FURTHER INFORMATION

Pl. Ref: 26/60878

RESIDENTIAL DEVELOPMENT
AT CONFEY , LEIXLIP
COUNTY KILDARE

Further Information 1: Design & Layout

Duplex Type J as amended with windows on gable

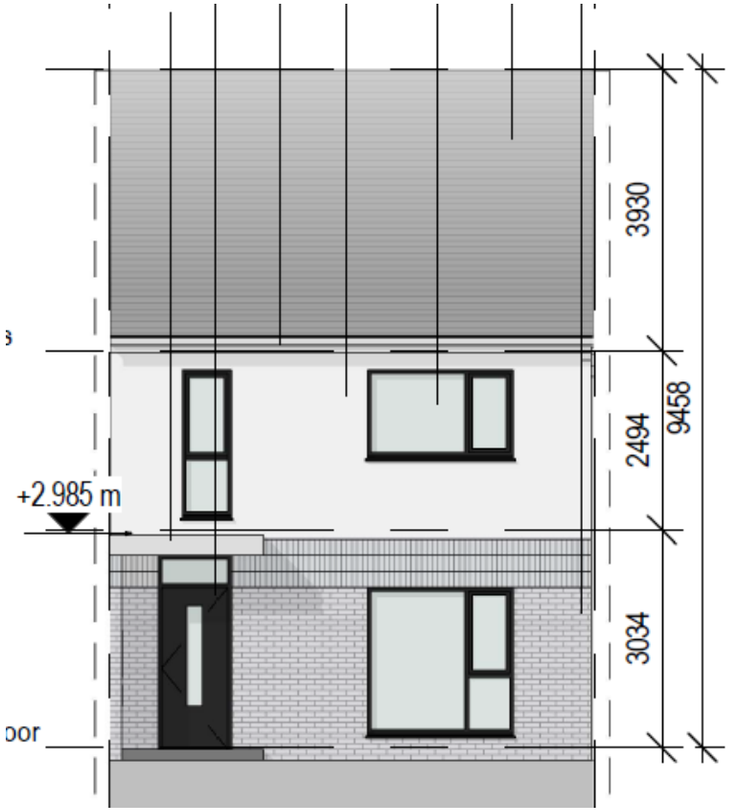
(a) Please note that there are concerns regarding duplex type J-J, which provides for blank gables at either end. It is considered that this is a poor urban design response at visually prominent locations in the proposed scheme. There are also concerns regarding the width of the window openings which are very narrow in some rooms including the bedrooms. It is considered that the narrow window openings add to the severity of the design of the three storey duplex buildings. It is considered that revisions are required to ensure windows are provided in the gable or that revisions are made to reduce the blankness of the gables.

The gable ends of the duplex block type J-J has been amended to include large windows on the ground and first floor.
The window openings have now also been widened.
Please see Drawing No.
2410-0560-Duplex Type J-J Proposed Plans and
2410-0561-Duplex Type J-J Proposed Sections & Elevations.

House Type C as amended with a Porch

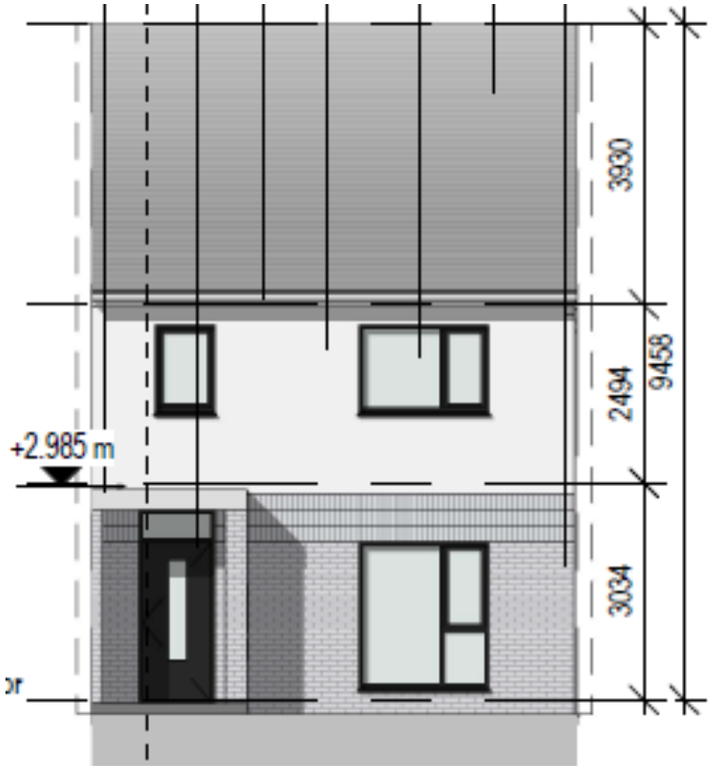
(b) Please submit revised proposals whereby a porch cover is provided for House Type C.

House type has been revised in include a porch cover over the front door.
Please see Drawing No.
2410-0530-House Type C Proposed Plans, Sections & Elevations

Eastern Elevation to Block A apartments and Creche

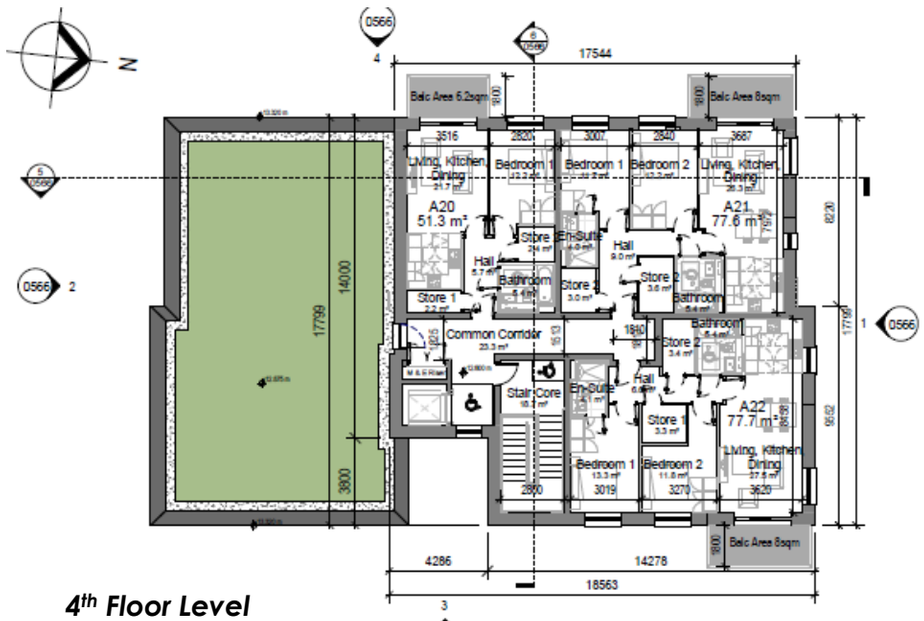
(d) It is considered that a revised colour palette is required throughout the development. It is considered that the apartment block should have one brick type throughout or a softer/lighter brick colour, the darker brick should be omitted from the proposed apartment block. The Applicant is advised to consider a brick finish similar to the lighter brick associated with the housing in Harpurs Lane in Leixlip.

Darker brick elements removed from apartment Block A. Selected Brick to be similar to brick used in the Cairn Homes development at Harpur lane, Leixlip.

4th Floor Level

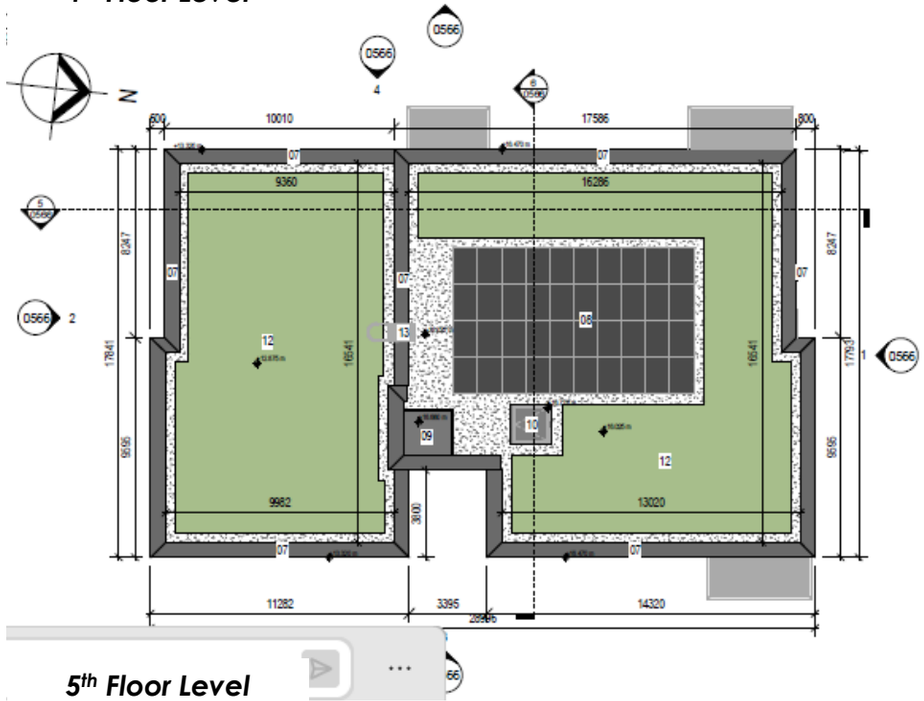
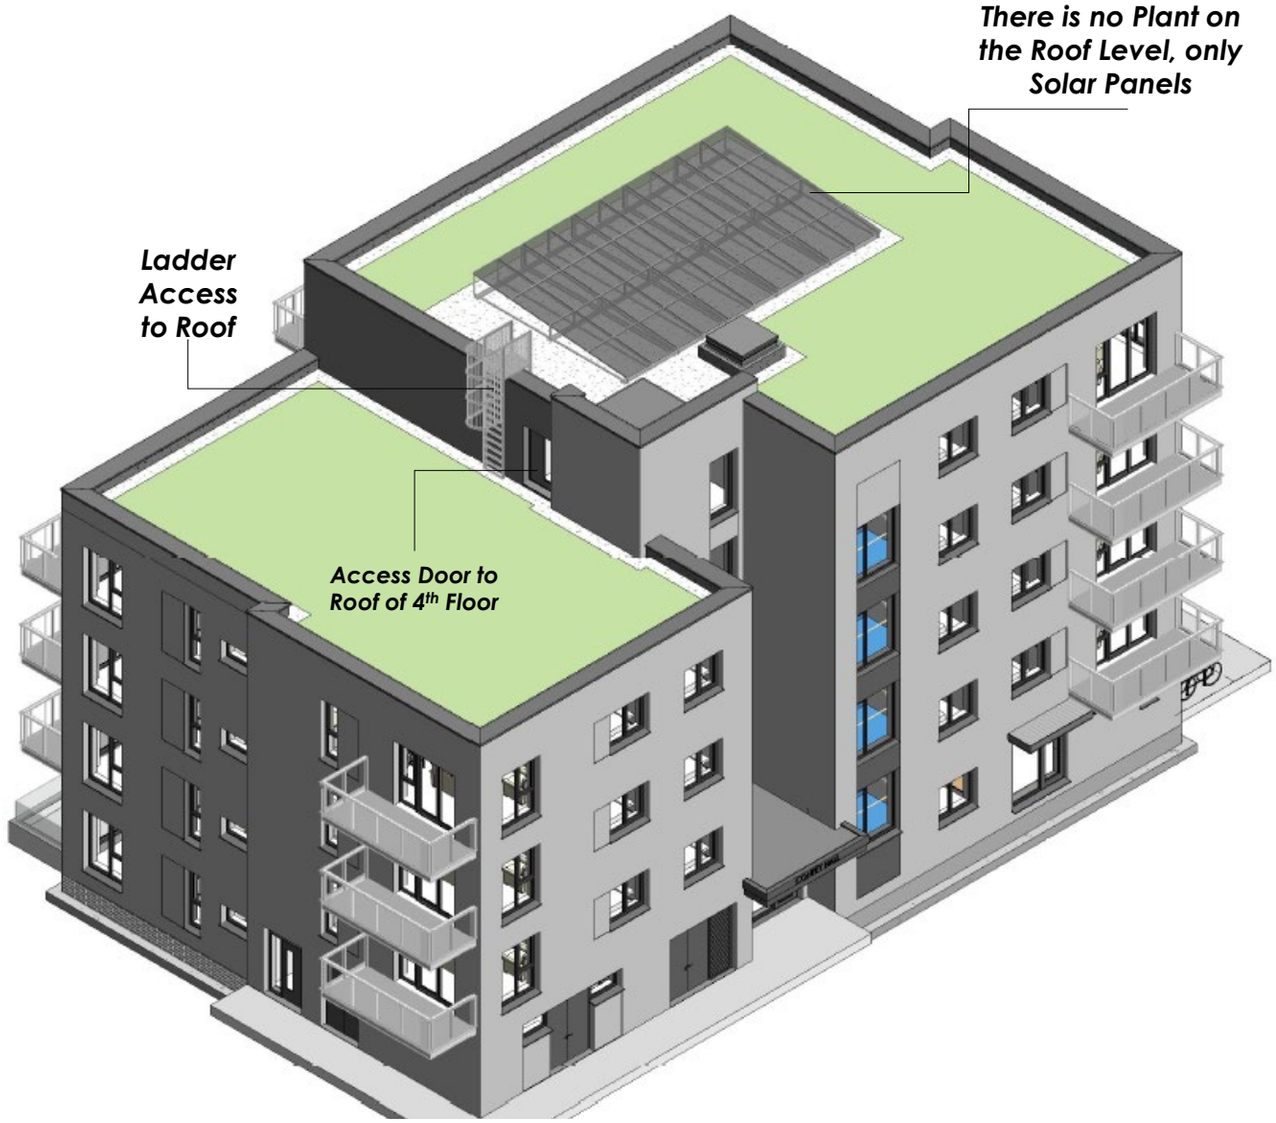
(g) It is noted that the Masterplan for R5 lands within the Confey Masterplan allow for building heights of 2-4 storeys and while the Planning Authority may be willing to consider the proposed 5 storey building, please note that there are concerns that there may be substantial plant required at roof level which will add to the visual impact of the block at this location. The Applicant is requested to clarify what plant is proposed including staircases to the roof and clarify if a grass roof is proposed.

Please note that all the Plant for the building is on the Ground Floor. The only Plant on the roof are the Solar Panels which are laid almost flat so as not to extend above the Parapet.
Access to the roof of the 4th Floor is via the Stairwell on the 5th Floor.
Access to the roof of the 5th Floor is via a protected ladder hung from the Parapet.

Typical Back to Back situation where the distance is less than 16 meters. Here the distance between Unit No. 1; Type G1 and Unit No. 19; G1 is 14.727 meters. There are no overlooking windows however.

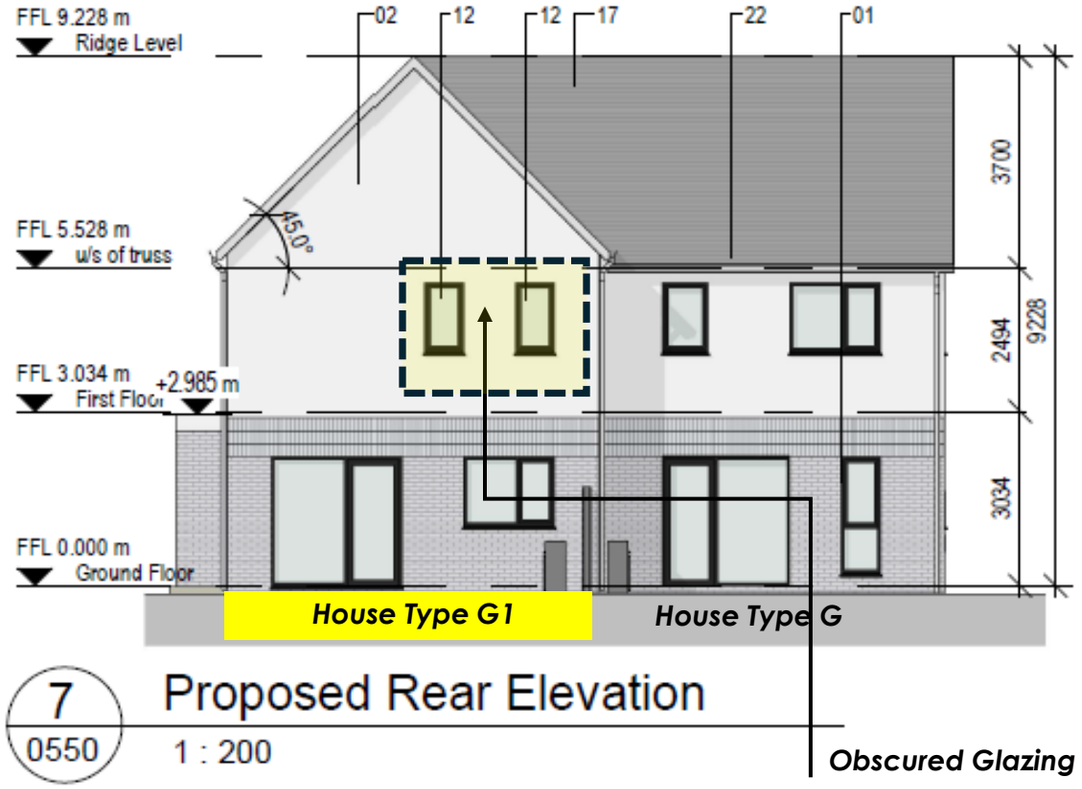
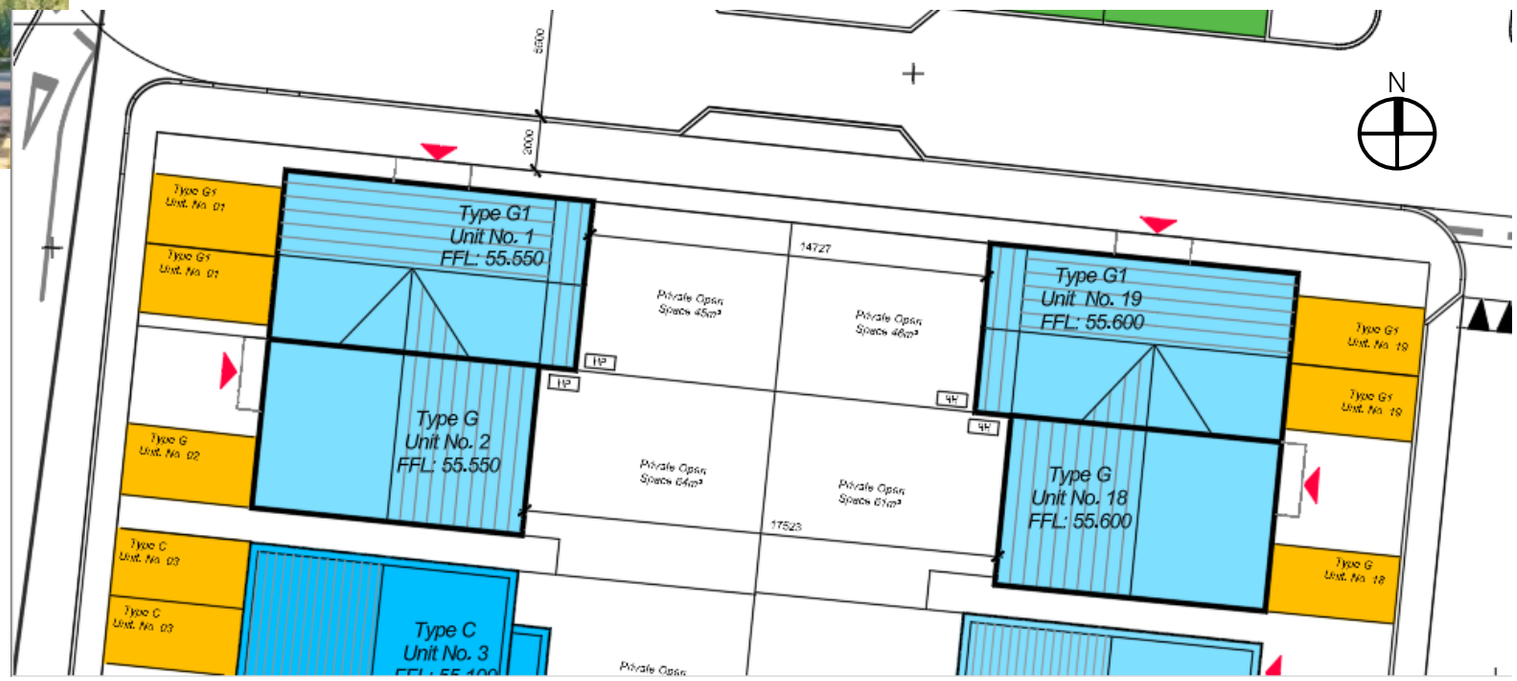
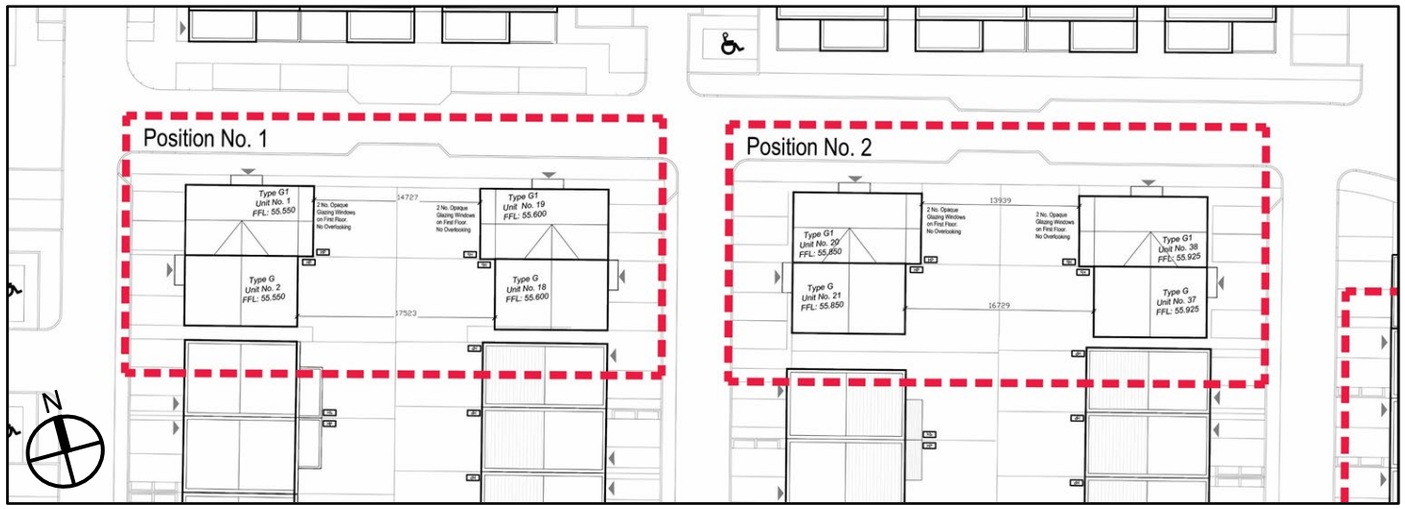
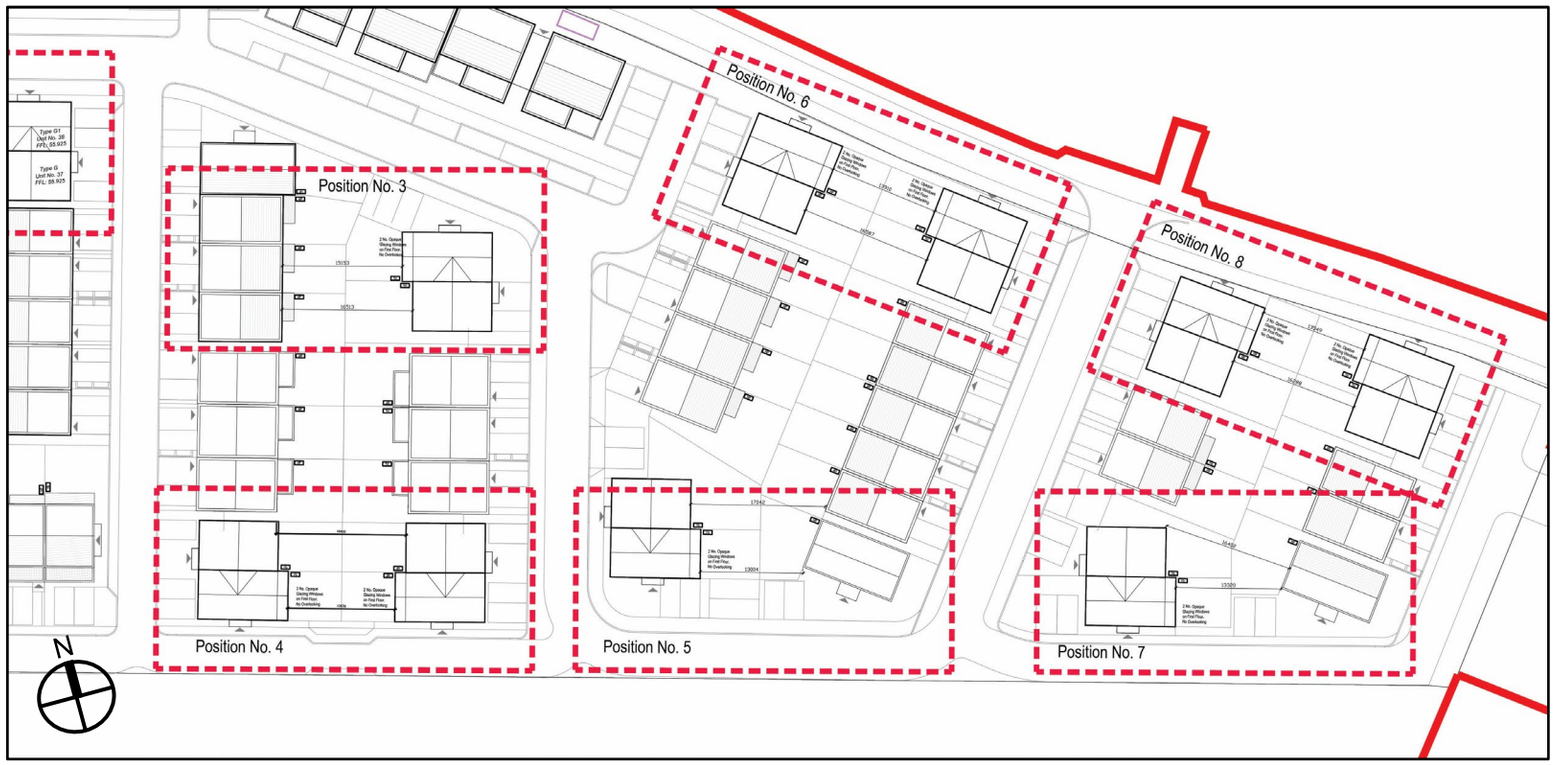
(e) The Applicant is requested to clarify where less than 16 metres is provided at back to back housing. Please submit cross sections clearly showing any occurrences where less than 16 metres is being provided and note that the Planning Authority has concerns where the minimum requirements are not being met.

Anywhere that the back to back distance is less that 16 meters, there are no first floor overlooking windows. In the scenario where the back to back distance is less that 16 meters, it is the House Type G1 that is being utilised.
The first floor rear elevation of the House Type G1 has two obscured glazed windows. One is a secondary light source for the bedroom, the other being an EnSuite window.

Anywhere that the back to back distance is less that 16 meters, there are no first floor overlooking windows.
In the scenario where the back to back distance is less that 16 meters, it is the House Type G1 that is being utilised.
The first floor rear elevation of the House Type G1 has two obscured glazed windows. One is a secondary light source for the bedroom, the other being an EnSuite window.
There is no overlooking.
Neither of these window are necessary for daylight.
One being to the EnSuite and the other being just a secondary source of light to animate a rear elevation.
This scenario occurs in 8 number locations highlighted by the red dashed boxes on this page.
See Dimensions.

Apartment Block A
Creche Area in Red Dashed Line

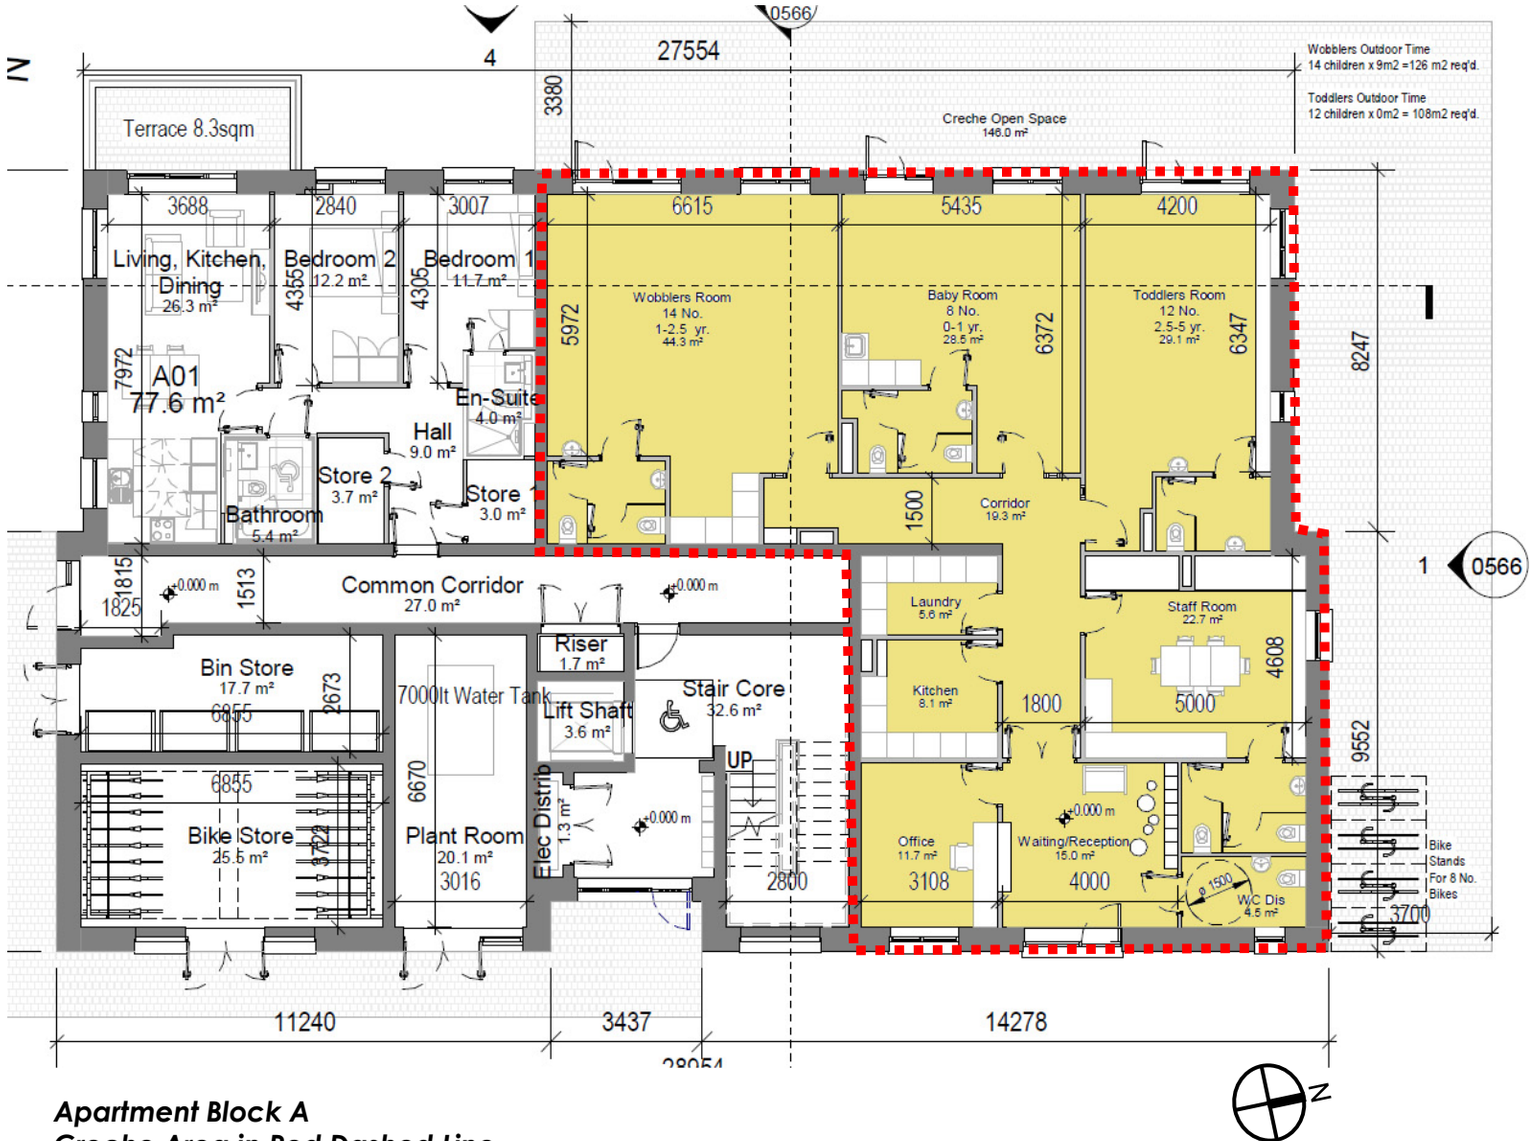
Please note that there are concerns that a childcare facility is not being proposed as part of the proposed development. While the details contained within the SIA and childcare assessment are noted, there are concerns that there is a reliance on facilities that have not yet been constructed and or/permitted. While the larger crèche currently proposed on the site at Reg. Ref. 26/60746 is noted, this does not yet have the benefit of planning permission. It is considered that a creche should be provided or designed into the proposed scheme should these other facilities not be developed in tandem with the current proposal for 125 no. units. If a childcare facility is not required at a later date, it is considered that there is potential for the building to be used as a community facility. The Applicant is requested to submit revised proposals to address this concern.

Please see 34 child Creche accommodated on the ground floor of the Block A apartment building..

The facility for 34 children is 218 sq.m. and fronts onto the main access route.
It is on a single level with a secure area of 126 sq.m. private play area.
There is secured bicycle parking to the side of the creche for 10 no. bikes including Cargo bikes.
The creche is fully accessible, provided with ramps and steps for the ambulant disabled.
It has close access to an open space area to the west and to the new public open space to the west via a pedestrian friendly network of streets and paths
